**Occupational Risk Consequences of the Department
of Energy's Approach to Repository Design,
Performance Assessment and Operation in the Yucca
Mountain License Application**

1018058

Technical Update, August 2008

Figure 6 - 1
DOE Seismic Hazard Curve Adapted for Post-closure Use [reproduced from Stepp et al. (2001), Figure 1.7-7]

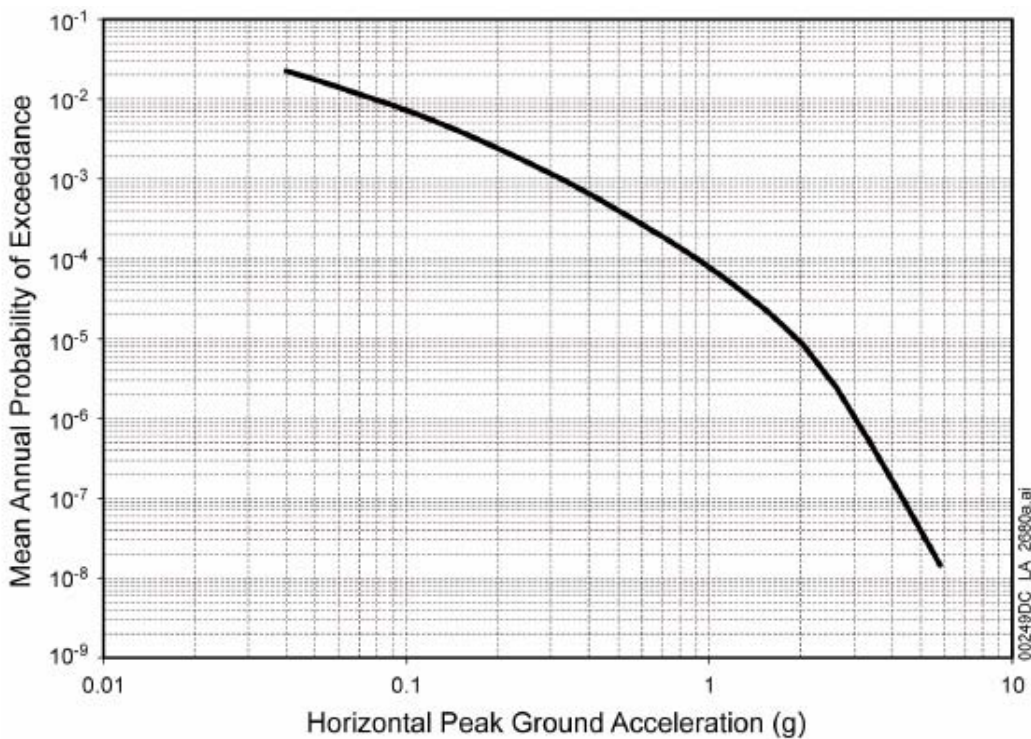
DOE uses ground motions estimated from its Yucca Mountain Probabilistic Seismic Hazard (PSH) model (Stepp et al. 2001). The seismic hazard curve in Stepp et al. (2001) is reproduced here as Figure 6-1. At return periods of 10^6 years, the Yucca Mountain PSH model predicts a mean PGA and PGV of 3g and 400cm/sec, respectively. These are ground motions that exceed the largest magnitudes ever recorded in the world, so there is some uncertainty as to whether they are physically realistic (Bommer et al. 2004). The PGA curve (presented in Figure 1.7-7 of DOE, 2008b) and reproduced here as Figure 6-1, is an extrapolation of the PSHA curve to 10^6 /year and beyond. It is important to recognize that a statistical distribution is just a model of observed data, and extrapolation beyond the range of the data may not be valid. EPRI asserts that the extrapolation of the maximum horizontal acceleration is beyond the region that could be supported by the strength of the rock and soil at Yucca Mountain. In a review of the results of this PSHA, an expert panel convened by the USGS (Hanks, et al., 2006), concluded the following:

This statement reflects the fact that even the authors of the ground motion assessment at Yucca Mountain believe that their results are too high and not credible for design. Their use is only recommended for sensitivity studies. Therefore, it is reasonable to conclude that the consensus in the community of earthquake professionals that ground motion estimates at Yucca Mountain are too high at probabilities of 10^{-6} /year and should be lower.

Therefore, EPRI has chosen to apply a 0.75 m/s peak ground velocity (PGV) with a 10⁵ year recurrence interval, so that repeated seismic events have been stylized as 10 large events over a 10⁶ year period, spaced out equally in time (EPRI, 2006b). These large events are those that have

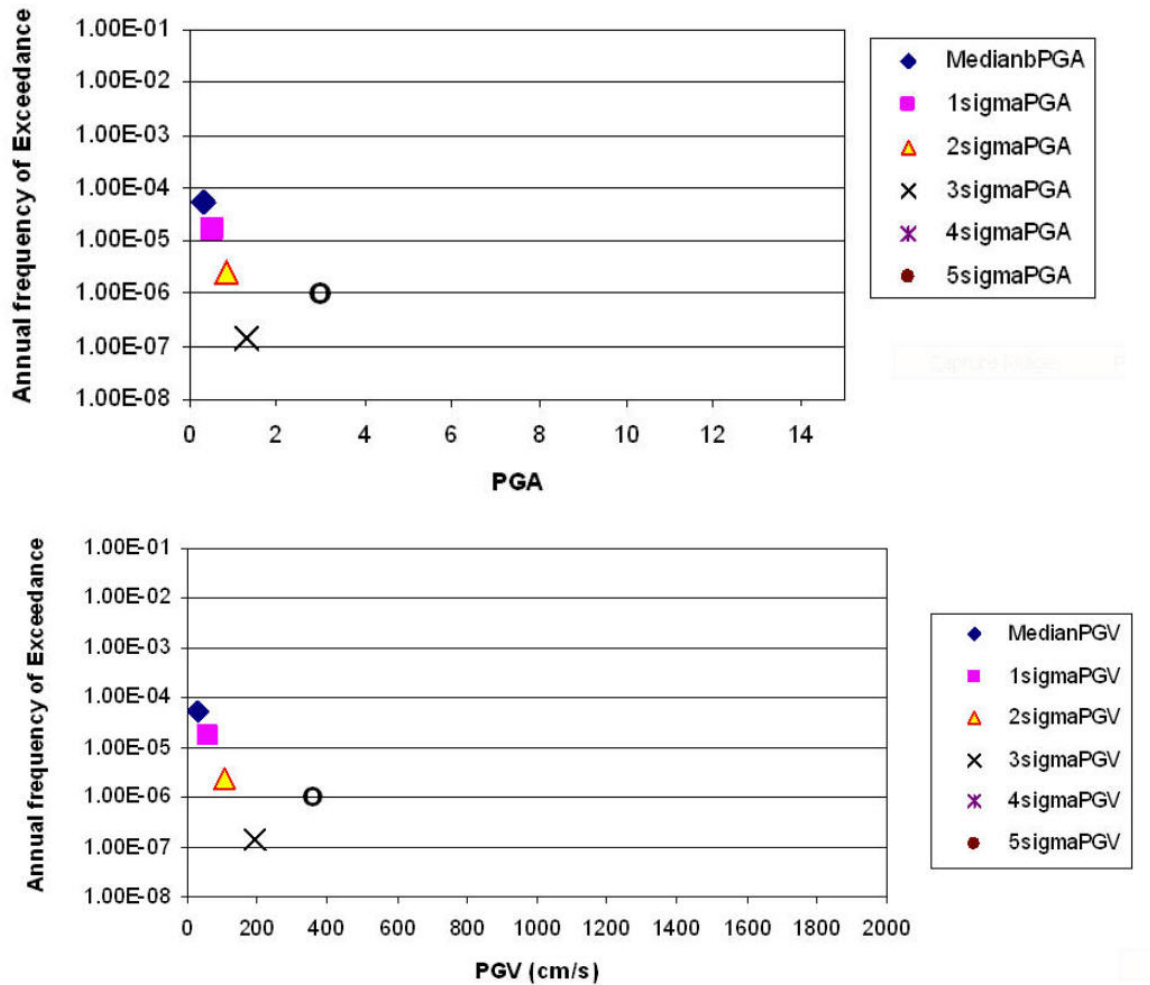
Figure 6-2 shows EPRI's estimates of the annual frequency of exceedance for PGA and PGV for the SCF and a background earthquake. Each horizontal line of three matching symbols on Figure 6-2 reflects the range of magnitudes estimates for the SCF (EPRI 2006b, Table 2-1). The open circles on the graphs represent the mean PGA and PGV for the 10^6 year return period from the Yucca Mountain PSHA (Stepp et al., 2001). The analysis shows the PGA to be about 0.7 to 1g for the SCF at the 10^{-6} /yr annual frequency of exceedance, (10^6 year return period), considerably less than the 3g estimated from the Yucca Mountain PSH model for the same return period. A PGV of 70 to 160 cm/sec is estimated for the SCF at the same annual frequency of exceedance or return period, considerably less than the 400 cm/sec derived from the Yucca Mountain PSHA. Similar results are obtained for the background earthquake (Figure 6-2).

Figure 6 - 3
Finite Element Model and Analysis Setup for Impact due to Rockfall (taken from Figure 12-1 in EPRI (2005))

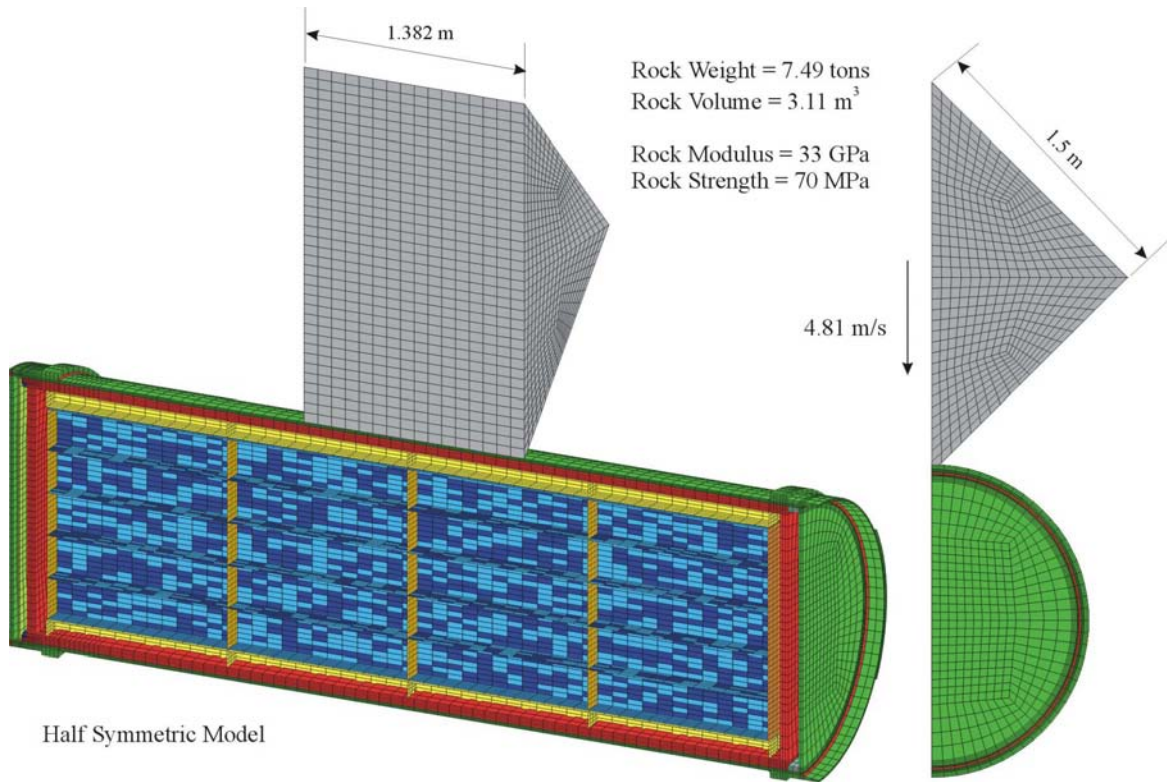
For dynamic loading, EPRI (2005b) conservatively assumed that a large rock block is ejected directly onto the top of a bare WP (i.e., without the DS present), as shown in Figure 6-3. EPRI used an Alloy 22 thickness of 20 mm. The rock block EPRI modeled was assumed to be 7.49 metric tons with a volume of 3.11 m³. This size of rock is the largest size in a representative grouping considered to have a reasonable probability of occurring for the maximum PGV of 2 m/s that EPRI has determined should be associated with a future seismic event near the Yucca Mountain site. This block was assumed to be ejected with a downward velocity of 2 m/s. Furthermore, EPRI (2005b) conservatively assumed that the rock block struck the unprotected WP on a knife edge (see Figure 6-3). EPRI has concluded that even in the event of the

Hence, it is EPRI's position that dynamic rockfall directly onto a WP – without the presence of a DS – will not cause any additional damage compared to the case for which a DS was present. Thus, drips shields are not needed to protect a WP from dynamic rockfall.

Figure 6 - 4
Derived Cumulative Failure Curves for Zircaloy Cladding (EPRI, 2000)

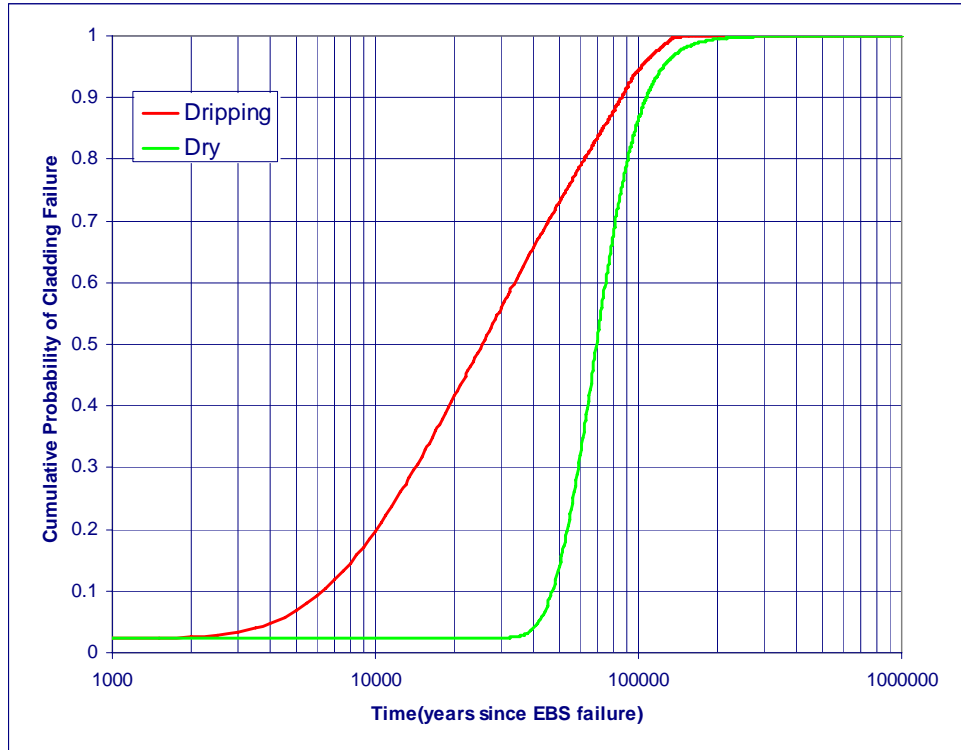
DOE has conservatively assumed that the CSNF cladding will not provide any sort of barrier to the delay or release rate of radionuclides from the UO₂ waste form [DOE 2008b, Section 2.4.2.3.2.3.2.3]. Neither has DOE taken credit for the performance of the inner stainless steel canisters within the waste packages or the outer stainless steel shell of the TAD. Without taking any credit for the performance of cladding or the inner stainless steel barriers, the performance of drip shields would seem to be more important than it really is.

EPRI does find that there is sufficient basis for taking credit for the performance of the CSNF cladding in its TSPA model (EPRI, 2000). Available data on the corrosion of zircaloy CSNF cladding were evaluated to derive an estimated cumulative failure curve as a function of time (Figure 6-4). It was assumed that approximately 2% of the cladding was failed prior to emplacement in a repository. After eventual failure of the waste package/EBS, two corrosion modes for the cladding were considered: (1) general corrosion under dry (moist air) conditions, and (2) general corrosion under dripping conditions. At 10,000 years after EBS failure, about 20% of cladding was projected to have failed under dripping conditions and no additional cladding failures were predicted to occur under dry conditions (EPRI, 2000).

Figure 6 - 5
Comparison of EPRI's Base Case (a) and No Drip Shield (b) TSPA Results

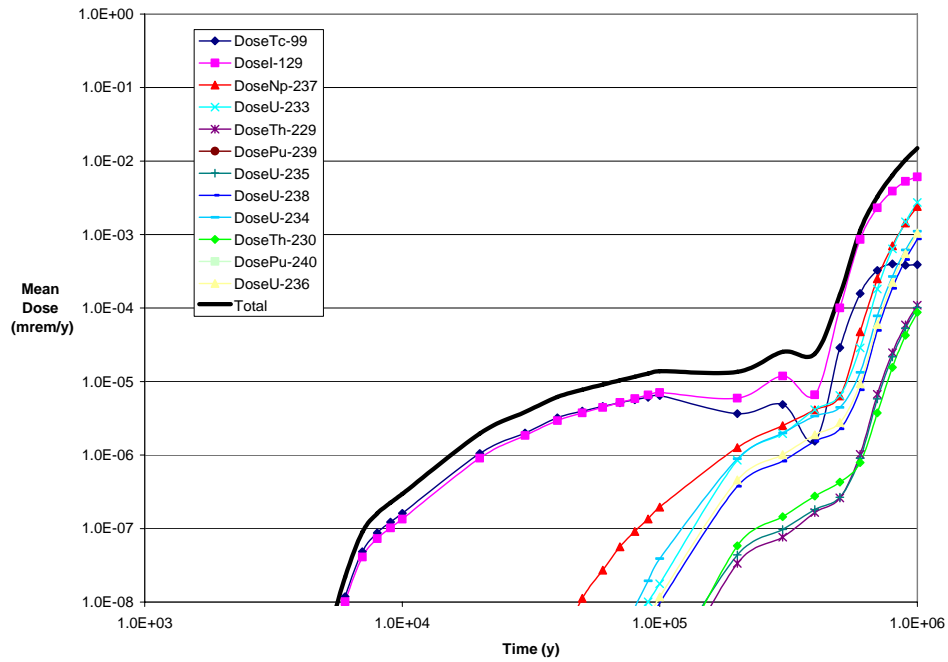
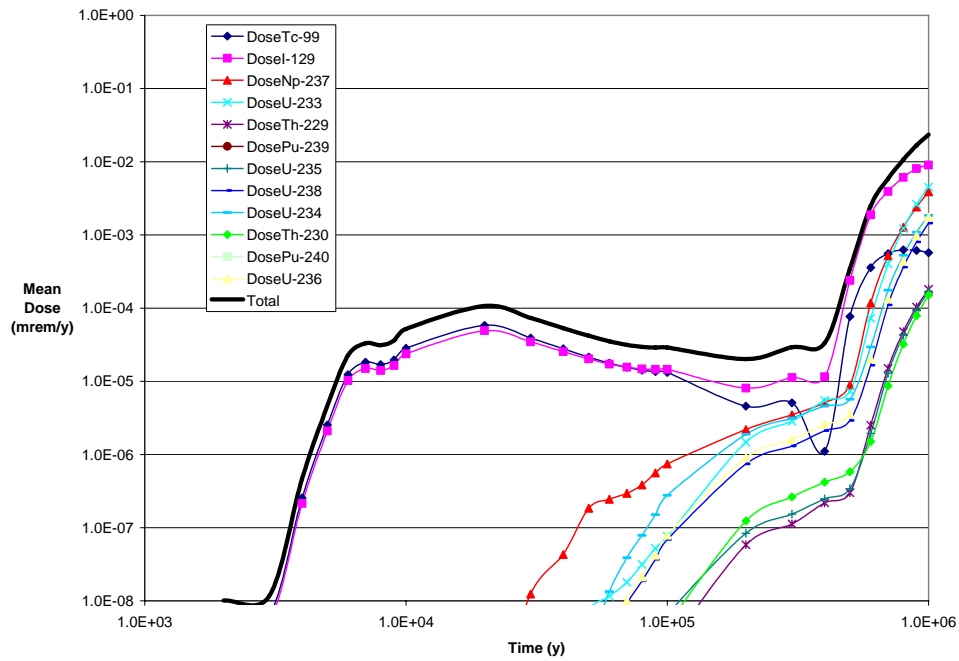
EPRI performed a TSPA analysis using its IMARC code to compare EPRI's Base Case (drip shields present) and a sensitivity study for which EPRI assumed the drip shields were not present. Figure 6-5 shows the IMARC results for the Base Case (Figure 6-5a) and that for no drip shields (Figure 6-5b). There is a moderate increase in doses at early times associated with the waste package that is assumed to be initially failed owing to manufacturing defects. It is noteworthy that even in the EPRI analyses, the assumption of one initially failed waste package is a conservatism as the expected value of waste package failures from manufacturing defects is

significantly below one. The change in peak dose without the presence of the drip shields is negligible, and is still well below the limits established in the proposed EPA/NRC standards.

Figure 7 - 1
DOE Horizontal Seismic Hazard Curve [adapted from DOE 2008b, Figure 1.1-89]

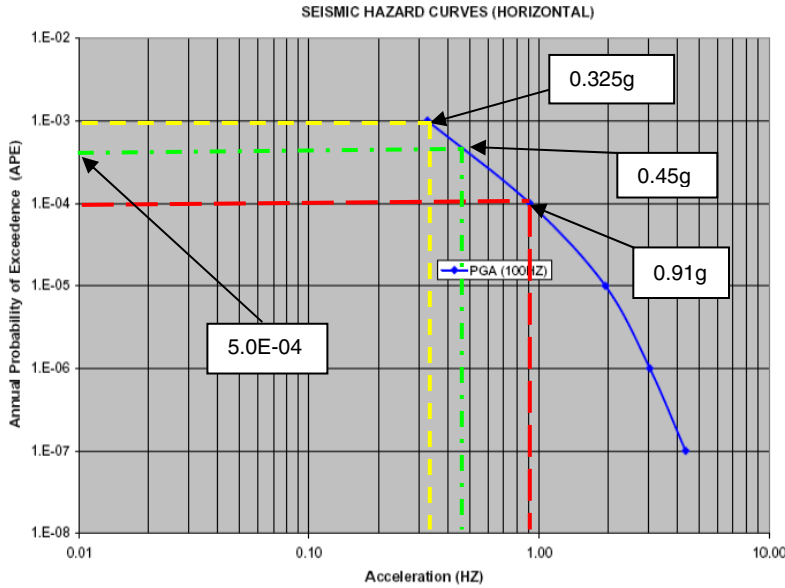
- Events with a mean annual probability of exceedance (MAPE) of 5×10^{-4} (2,000-year return period), designated as Category 2 events. (0.45g, as shown on Figure 7-1)
- BDBGM (Beyond Design Basis Ground Motion) are events with a MAPE of 10^{-4} (10,000-year return period). (0.91g, as shown on Figure 7-1)

Figure 7-1 (BSC, 2007a, p. 75) shows the horizontal seismic hazard curve that DOE is using for the YMP. The figure shows the values of horizontal peak ground acceleration (PGA) at 100 Hz applicable to the design of the surface facilities. The critical evaluation for safety purposes is the Beyond Design Basis Ground Motion (BDBGM) event, which is 0.91g for the return period of 10,000 years.

Figure 8 - 1
 DOE estimates of RMEI mean annual dose for the 0 to 10,000- (upper figure) and 0 to 1,000,000-
 year (lower curve) time frames (taken from Figure ES-58 in DOE, 2008b).

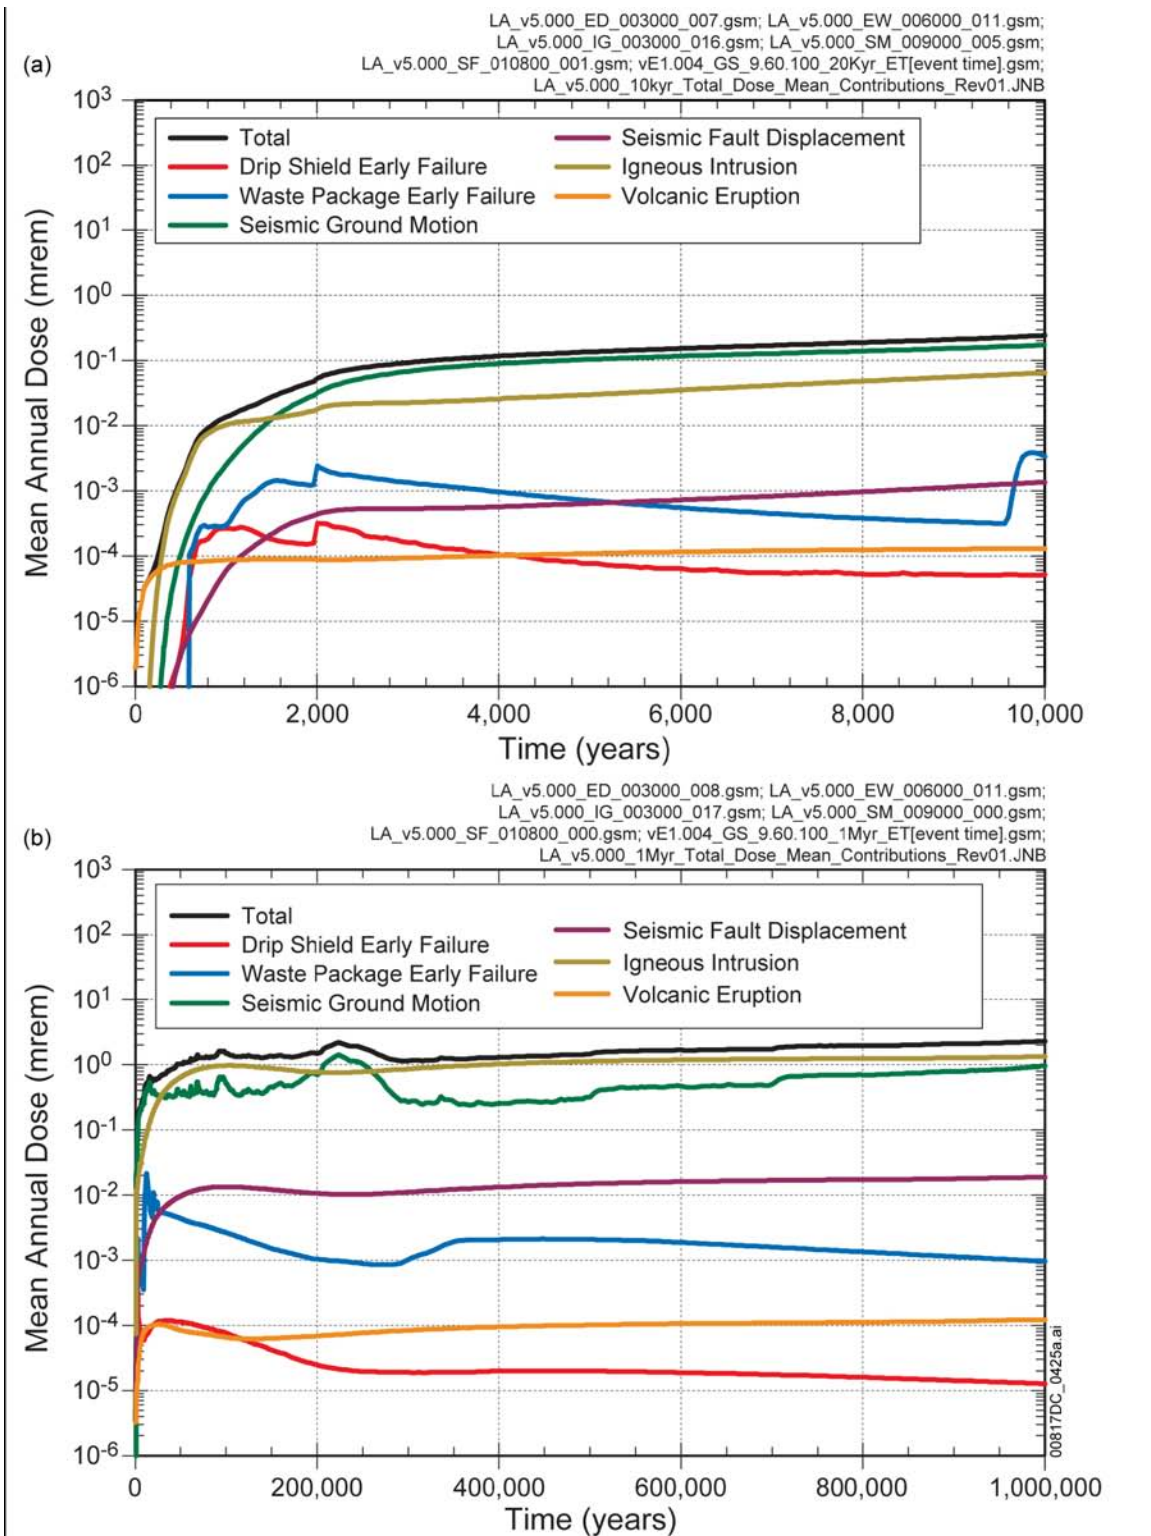
As shown in Figure 8-1, DOE's overestimate of post-closure seismic risk and repository performance effects has caused DOE to find that a major contributor to peak RMEI dose is due to seismic ground motion. While it is not possible to estimate the results DOE would have produced if it had used more reasonable seismic risk and repository performance effects assumptions, it is likely the dose rate estimate for this scenario would be lower, perhaps considerably so. If the igneous intrusion and eruptions scenarios had been eliminated from consideration, as EPRI states is appropriate in Section 5 of this report, and more reasonable estimates of seismic risk and repository performance were used, it is quite possible that the resulting total dose estimates DOE would have derived would be as much as two orders of magnitude lower. If so, this would cause DOE's peak dose results to be fairly similar to the results calculated by EPRI (shown in Figure 8-2).

DOE notes that the first peak in its RMEI dose estimate, shown in the lower figure in Figure 8-1, is primarily due to failure of the defense co-disposal waste packages. This peak rivals that of the ~1,000,000-year peak caused primarily by the TADs containing CSNF. While EPRI finds significant conservatisms in DOE’s TSPA analyses for both the co-disposal and TAD waste packages, DOE’s performance assessment results may cause an unnecessary amount of regulatory scrutiny to be placed on the co-disposal waste package behavior. If so, then the repository licensing process may take longer to complete, thereby resulting in a potential delay in the opening of the repository.
